Project	<b>IEEE 802.16 Broadband Wireless Access Working Group</b> < <a href="http://ieee802.org/16">http://ieee802.org/16</a> >
Title	<b>Amendment to Location Update Primitives in Section 14.2.4.3</b>
Date Submitted	<b>2007-03-08</b>
Source(s)	JeeHyeon Na, Jaesun Cha, JungMo Moon and Sangho Lee <a href="mailto:jhna@etri.re.kr">jhna@etri.re.kr</a> ETRI 161 Gajeong-dong, Yuseong-gu Daejeon 305-700 Korea
Re:	Contribution on comments to IEEE 802.16g/D8
Abstract	Re-definition of location update service primitives in section 14.2.4.3
Purpose	Adoption
Notice	This document has been prepared to assist IEEE 802.16. It is offered as a basis for discussion and is not binding on the contributing individual(s) or organization(s). The material in this document is subject to change in form and content after further study. The contributor(s) reserve(s) the right to add, amend or withdraw material contained herein.

# Amendment to Location Update Service Primitives in section 14.2.4.3

*JeeHyeon Na, Jaesun Cha, Jungmo Moon and Sangho Lee*

Figure 484 – Location Update Primitives

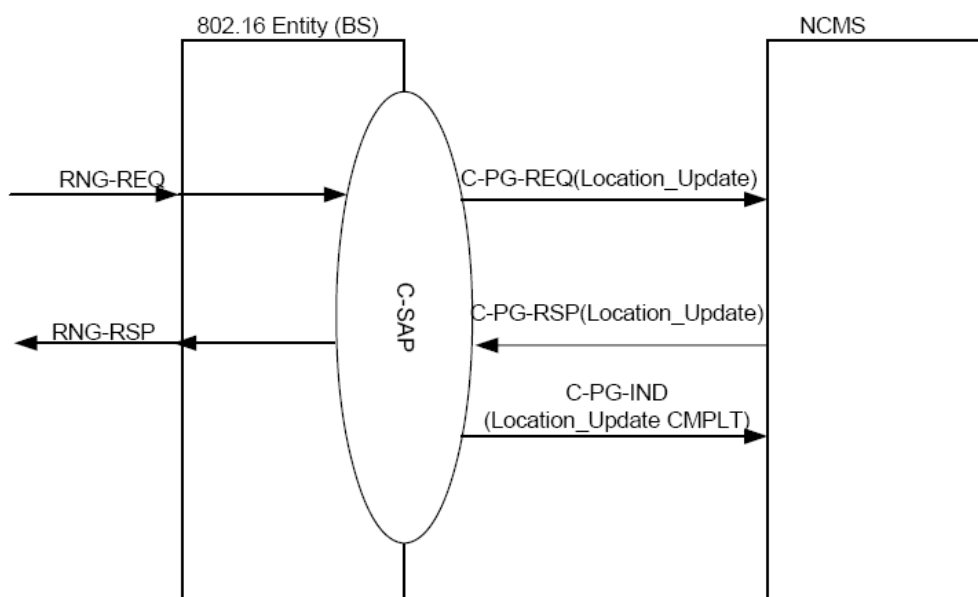
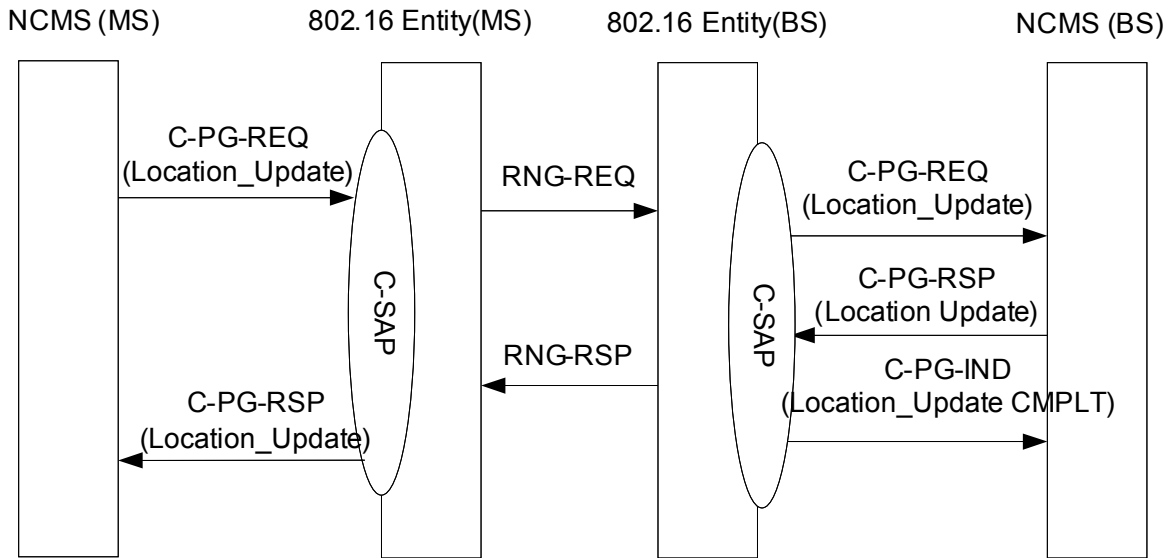
Therefore, we modify the figure 484 and some related texts to be included service primitives between an 802.16 entity (MS) and an NCMS on MS side in this contribution.

All the above Location Updates are realized by Ranging request/response (RNG-REQ/RSP) message between an MS and a BS, and the C-PG-REQ, C-PG-RSP, C-PG-IND service primitives are defined between [a BS-an 802.16 entity](#) and the NCMS to perform Location Update.

Figure 484 shows service primitives for Location Update between [an 802.16 entity-a BS](#) and the NCMS.
